Access Compliance Report Public Rights-of-Way (Curb Ramps)

Main Street: N/A Cross Street: RED_HILL_AVE Location: N

ADA ID: RPRK220107114753 Ramp Type: Type 6 - Directional 1 Initial Pass/Fail: Pass Overall Compliance: No Severity Score: 16

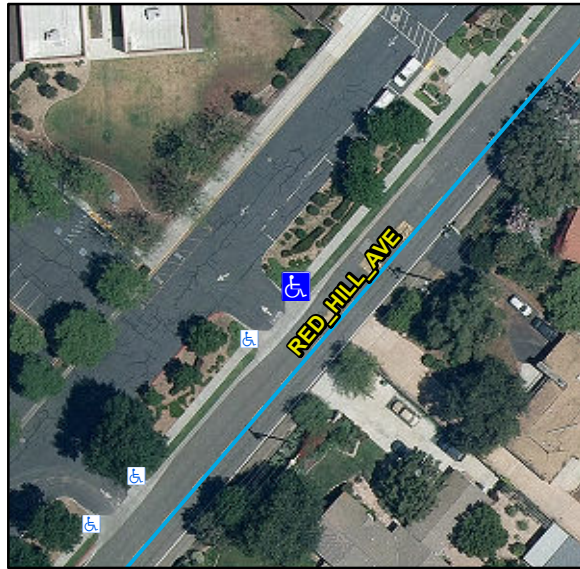
Compliance	Description	Data	Compliance	Description	Data
N/A	Ramp Length (in)	118	Yes	Flare Type LT	
Yes	Ramp Width (in)	58			Curbed2
Yes	Ramp Run Slope (%)	7.1	N/A	Flare Slope LT (%)	N/A
Yes	Ramp Cross Slope (%)	3.8	N/A	Flare Traversable LT	N/A
No	Grade Break	No	Yes	Flare Type RT	
N/A	Grade Break Slope (%)	N/A			Curbed2
N/A	Grade Break Cross Slope (%)	N/A	N/A	Flare Slope RT (%)	N/A
	Addl Para Ramp Left?	No	N/A	Flare Traversable RT	N/A
	Addl Para Ramp Right?	No	No	DWS Provided	No
N/A	Landing Present	Yes	N/A	DWS Contrast	N/A
Yes	Landing Length (in)	79	N/A	DWS Length (in)	N/A
Yes	Landing Width (in)	58	N/A	DWS Full Width	N/A
No	Landing Run Slope (%)	2.6		DWS Offset Type	N/A
Yes	Landing Cross Slope (%)	1.7	N/A	DWS Left Offset (in)	N/A
N/A	Landing Movement Obstructed?	No	N/A	DWS Right Offset (in)	N/A
	Landing Movement Type	N/A			
N/A	Landing Shared	No			
N/A	Marked Crosswalk 1	No	N/A	Clear Space	N/A
	Crossing 1 Direction	SW	N/A	Clear Space To Crosswalk (in)	N/A

Marked Crosswalk 1 Width (in)	N/A			
N/A	Ramp Inside Crosswalk 1	N/A			
	Crossing 1 Slope (%)	5.6			
	Crossing 1 Cross Slope (%)	9.1			
Yes	Gutter Ponding	No	Yes	Curb Slope	6.6
Yes	Gutter Lip Height (in)	0		Road Run Slope (%)	N/A
No	Gutter Run Slope (%)	6		Road Cross Slope (%)	N/A
No	Gutter Cross Slope (%)	8.7		Parallel Ramp Side	N/A
Yes	Overall Surface Condition	Acceptable	Yes	Perp Joint Present	Yes
	Cross Gutter Present?	Yes		Spandrel Present?	Yes
	Replace Cross Gutter?	No		Replace Spandrel?	No

Remove & Replace Entire Ramp. Remove & Replace Gutter.
